Mark E. Fesmire, P.E.
Director
Oil Conservation Division

LETTER OF VIOLATION - Inspection

PEARL JORDAN No.003

SUMMIT RESOURCES INC.
PEARL JORDAN #3 AND T/B.
P 17-4S-33E 30-04-20593

FLOWLINE LEAK 4' X 300' +/-

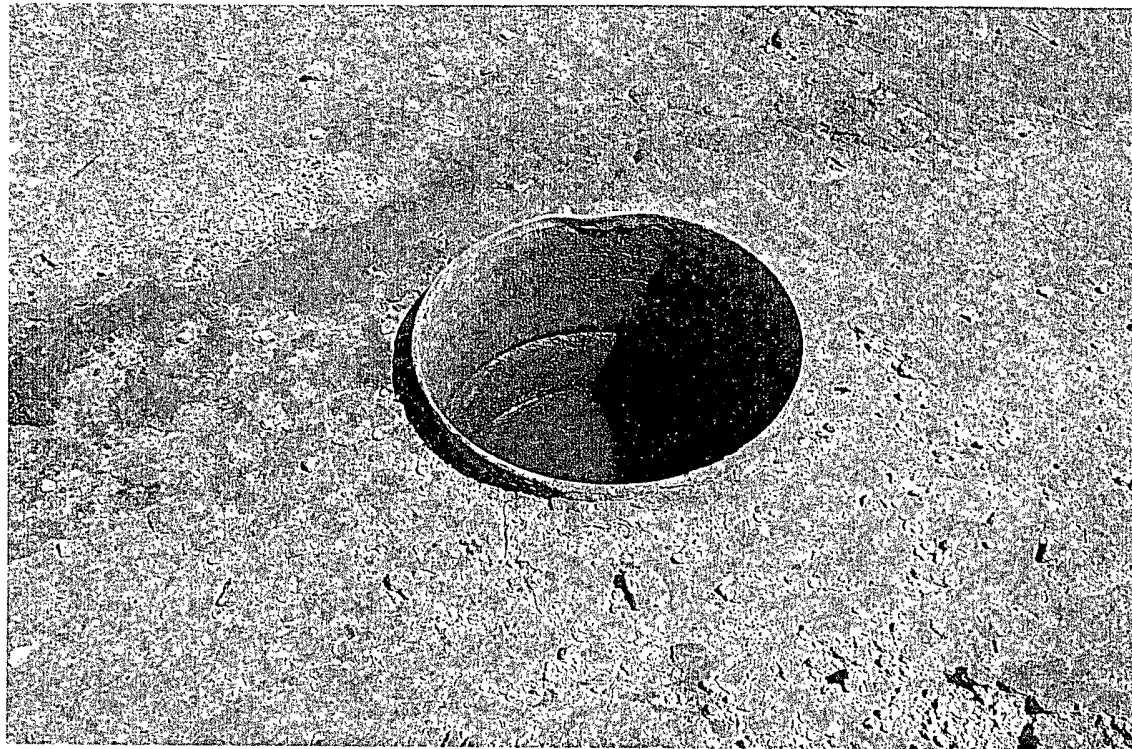
Comments on Inspection: FOLLOWUP ON COMPLAINT FROM WAYNE KINMAN-RANCHER IN REFERENCE TO FLOWLINE LEAK. NEED TO SUBMIT C-141 TO GEOFFREY LEKING (575-393-6161 EXT 113), HOBBS OCD DISTRICT 1 OFFICE FOR APPROVAL. RULE 19.15.29.8. ALSO NEED TO ADDRESS RELEASES AT TANK BATTERY. SEE PHOTOS-LOAD LINE, SUMP, AREA NORTHEAST OF HEATER TREATER AND AROUND WELLHEAD. SIGN AT WELL NEEDS CURRENT OPERATOR AND API#, RULE 19.15.16.8. NEED TO INSTALL SIGN AT TANK BATTERY, RULE 19.15.18.16. THIS IS 1ST LETTER OF NON-COMPLIANCE.

AREA AROUND WELLHEAD
←

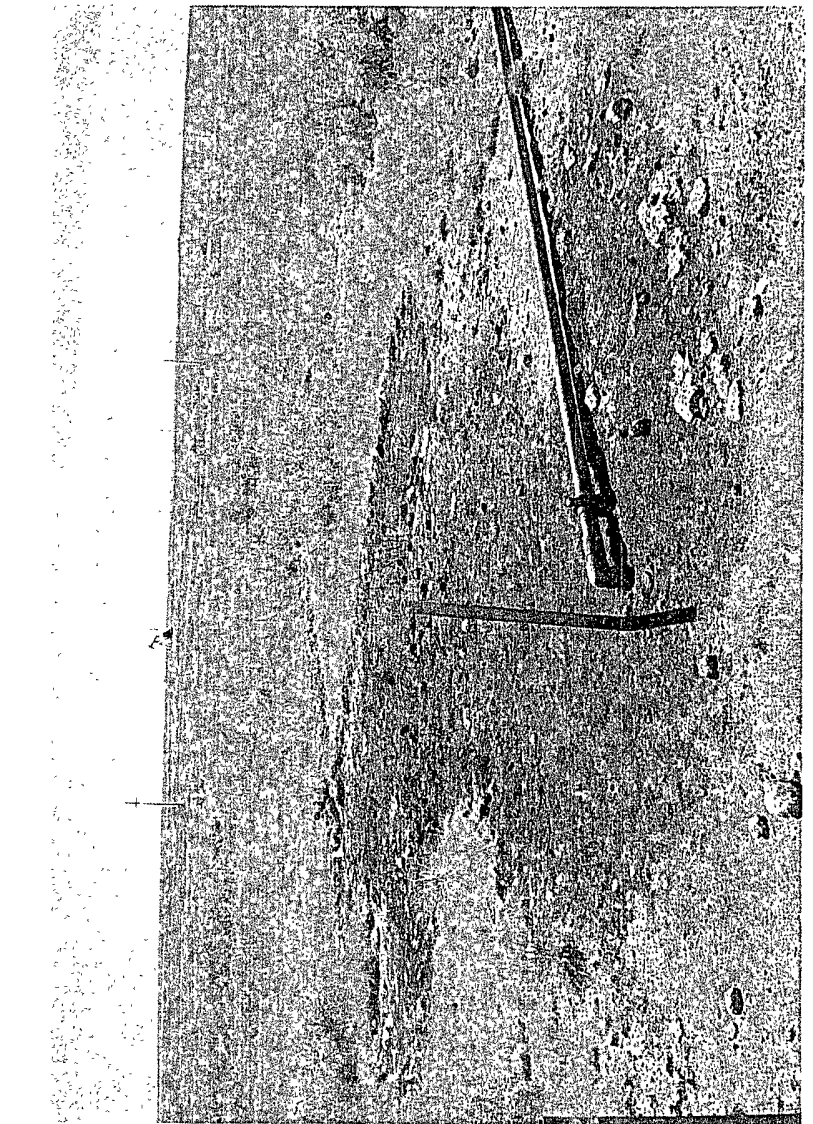
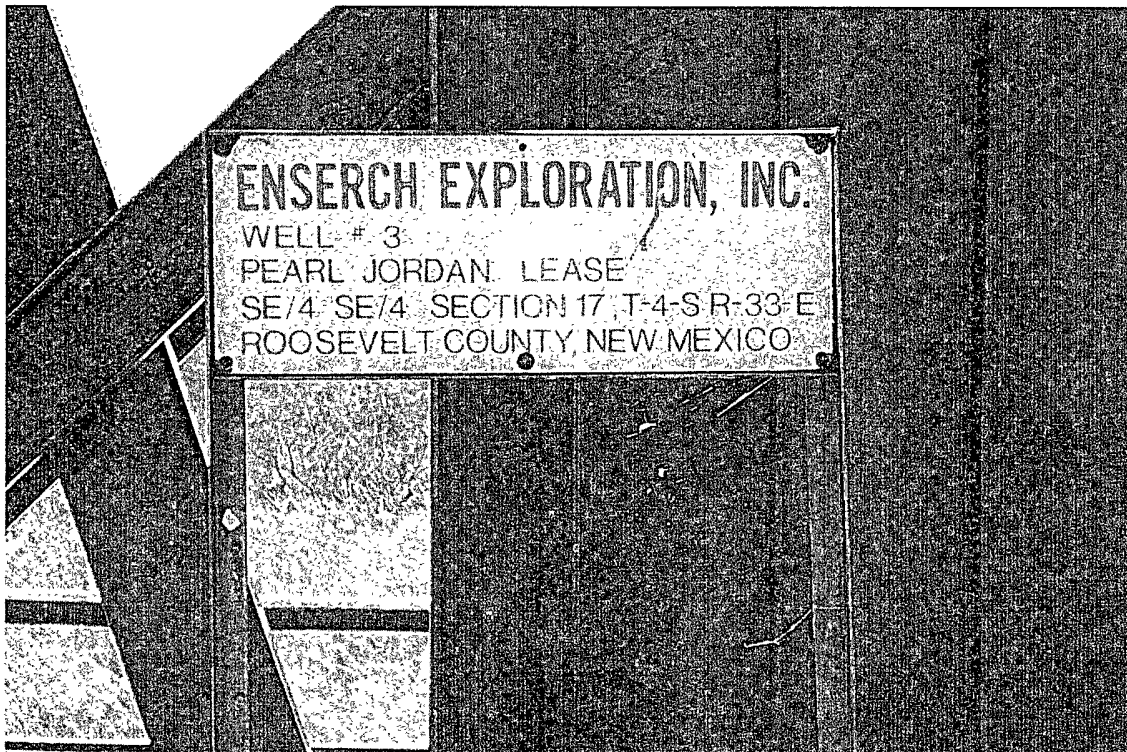
| AMOCO STATE No.002 | | | | M-16-4S-33E | 30-041-20544-00-00 | |
|---|------------------|--|------------|------------------------------|---------------------------|----------------|
| Comments on Inspection: | | Well Sign (Rule 19.15.16.8). NEED CURRENT OPERATOR ON SIGN. ALSO ADDRESS OIL STAINING AROUND WELLHEAD. THIS IS 1ST LETTER OF NON-COMPLIANCE. | | | | |
